Technical Service Bulletin

Mazda North American Operations Irvine, CA 92618-2922

POPPING AND/OR SQUEAKING NOISE FROM FRONT SHOCK ABSORBER AND/OR CREAKING NOISE FROM FRONT LOWER ARM BUSHING **Bulletin No.: 02-001/18**

Last Issued: 01/05/2018

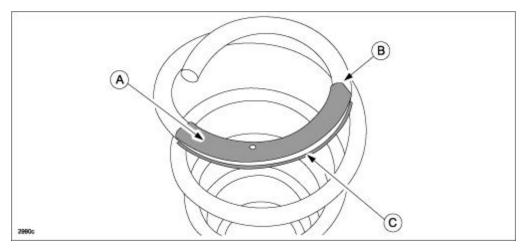
- For the squeaking and popping noise, the shape of the bump stopper has been modified and a protector has been installed onto the coil spring.
- For the creaking noise, the friction of the lower arm bushing has been reduced by adding a dry coating.

7. Install the protector (A) onto the coil spring aligning the end (slant cut side) with the marking at spot (B).

NOTE: Install the protector so the gap (C) is evenly aligned around the outer edge of the coil spring.

Bump Stopper Replacement

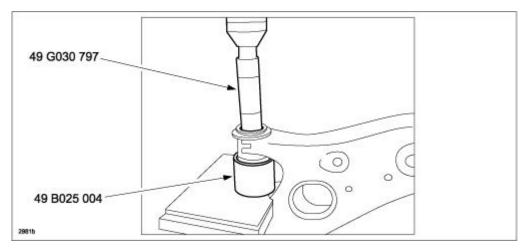
8. Replace the bump stopper with the modified one according to MGSS online instructions or the Workshop Manual (section 02-13 FRONT SHOCK ABSORBER AND COIL SPRING DISASSEMBLY/ASSEMBLY).

- Before removing the mounting rubber, mark its original position so it can be re-installed later to the same position.
- When replacing the bump stopper with a modified one, apply grease to upper side of the bump stopper and to the inside of the bump stopper (on the surface that contacts the damper rod).

CAUTION: It is not necessary to adjust the front wheel alignment because the front shock absorber and mounting rubber are not being replaced. However, make sure to install the mounting rubber to the original position.

Lower Arm Bushing Replacement

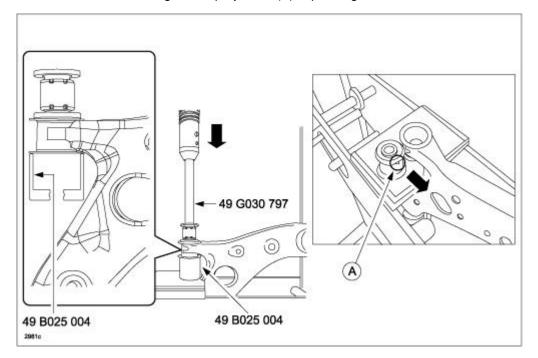
12. Install the modified bushing using the same SSTs.

- Before installing the new bushing, wipe the inside of the outer tube and make sure it is clean.
- Apply soap suds to the bushing to ease the installation.
- Always wipe off soap suds from the front lower control arm and bushing with a cloth.
- Install the bushing so the projection (A) is pointing toward the front of the vehicle.

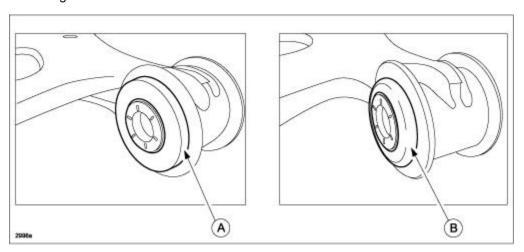
CAUTION: Make sure the bushing has been properly inserted by verifying that the bushing tab **IS FULLY EXPANDED**, as shown in the illustration to the left (A). The illustration to the right (B) shows an example of a bushing tab that **IS NOT FULLY EXPANDED**.

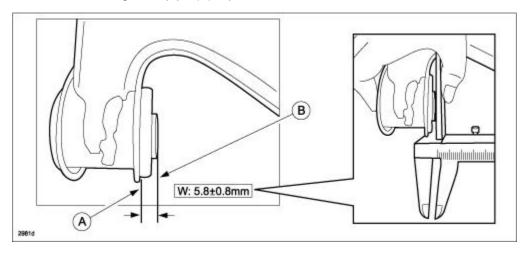
13. After installing the bushing, verify the distance between the front lower control arm (A) and front lower control arm bushing inner pipe (B) equals 5.8 +/- 0.8mm as shown below.
